Timbers of Black Forest Subdivision No. 1

Final Drainage Report

PCD File No: **SF2616**

All Terrain Engineering Project No: 25021

PROPOSED DRAINAGE MAP

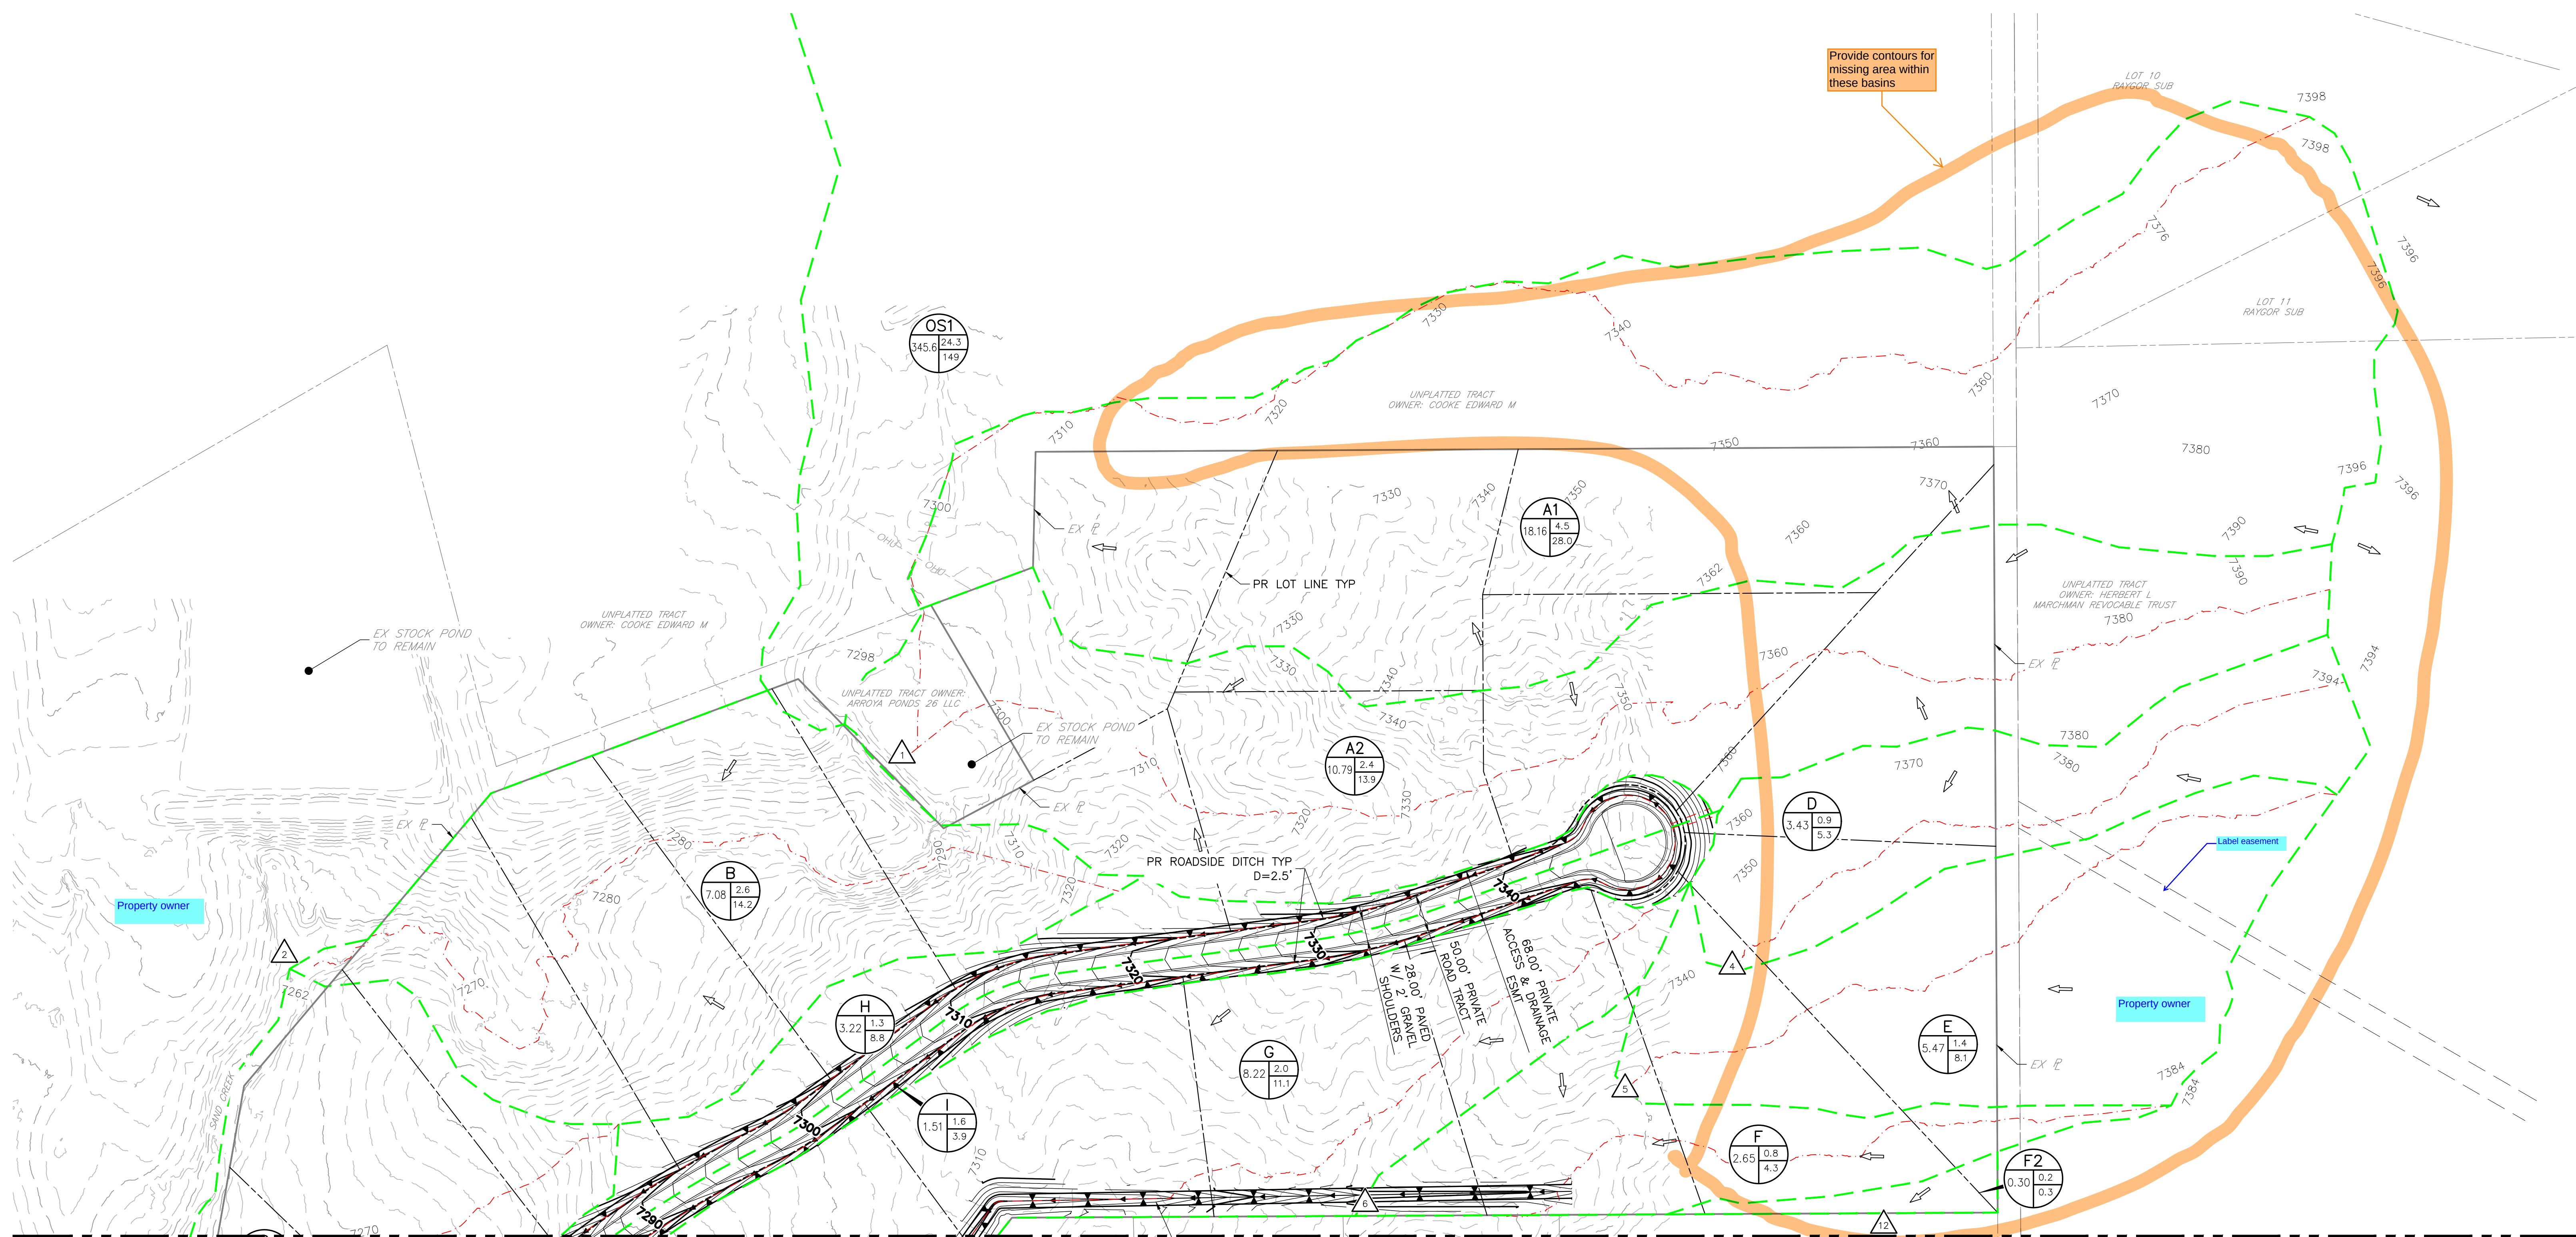
Based on the proposed drainage map in Appendix F, Basins G–M do not contain any areas that would be considered undeveloped. All areas are either 2.5-acre lots or gravel/paved surfaces associated with the private road. Please revise accordingly
